Palisades Nuclear Plant
Operated by Nuclear Management Company, LLC

Palisades Nuclear Plant
Docket 50-255
License No. DPR-20

**NMC Response to NRC Requests for Additional Information Dated September 28, 2005
Relating to License Renewal for the Palisades Nuclear Plant**

**NMC Responses to NRC Requests for Additional Information
Dated September 28, 2005**

DOME TENDONS

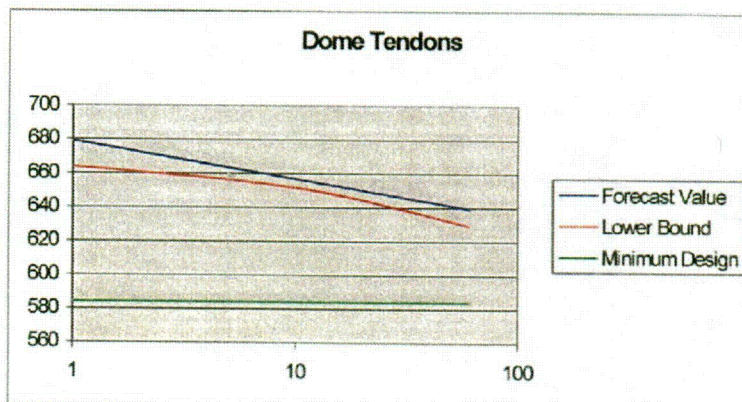
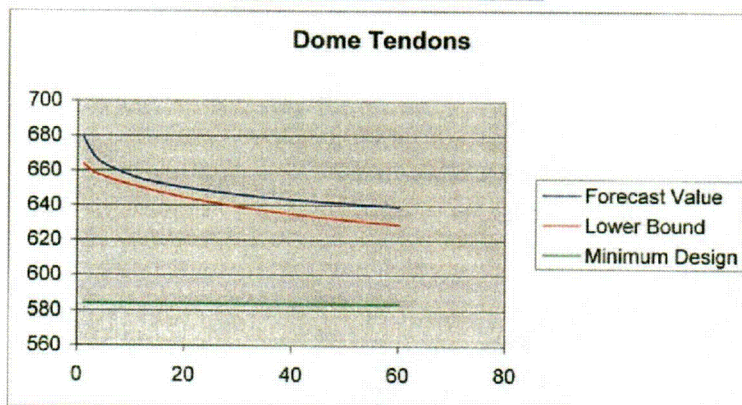
Based on the information provided in the response to RAI 4.5.2, the applicant is requested to explain how the 95% confidence curves provided in Enclosure 4 were established.

The regression analysis for each group of tendons using the data from the last surveillance report has been revised to project out to 60 years. Plots have also been added with time on a logarithmic scale. The results for the vertical and horizontal regressions are slightly different from those previously reported due to the following corrections: The test results from tendon V334 were incorrectly excluded from the vertical data. The test results from tendon 84DF were incorrectly included in the horizontal data.

The analysis results and plots of dome, vertical and horizontal tendon projections out to 60 years are provided below. These pages supersede the corresponding pages (40, 41, 42, 45, 47, 48 and 50) of Enclosure 4 to NMC letter of July 25, 2005. This information demonstrates the adequacy of the time limited aging analysis for the containment tendons.

VERTICAL TENDONS

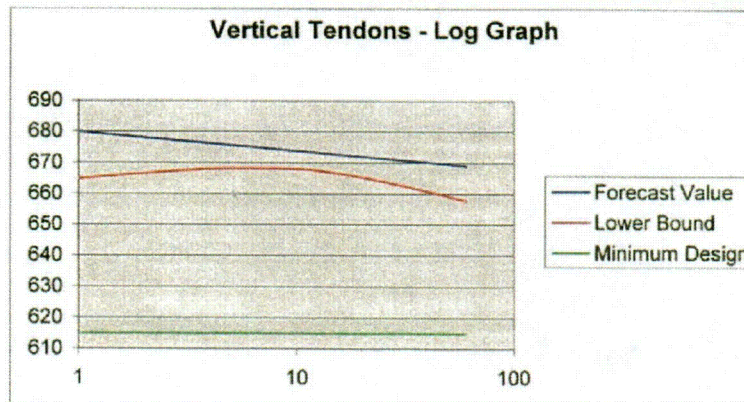
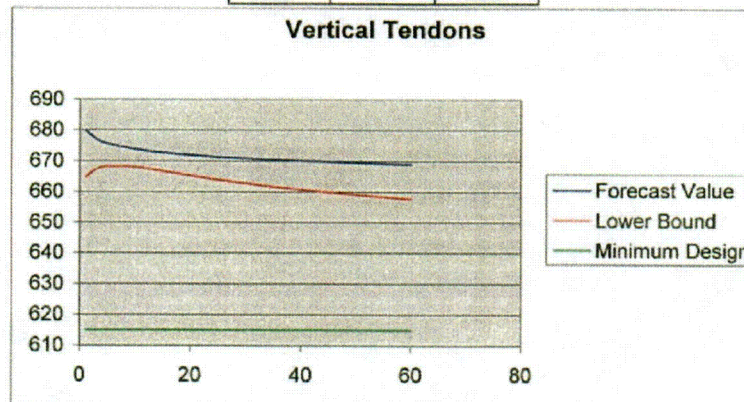
In response to RAI 4.5.3, the applicant provided a summary of the regression analysis data through tables and graphics in Enclosure 4. In the tables there are a number of tendons that appear to have been excluded from the analysis. These tendons are numbered as: D1-38, V334, and 65BF. The applicant is requested to provide the basis for exclusion of these tendons from the analysis.

Rev 1.

Included V334 which is common tendon and was excluded in error.

Increases projection at 60 years by 3 kips or 0.45%.

Tendon V334 was incorrectly excluded from the analysis. Apparently, V334 was mistakenly identified as V324, which was de-tensioned and re-tensioned during the first surveillance. The regression analysis prepared in response to RAI 4.5.2(b) includes tendon V334.
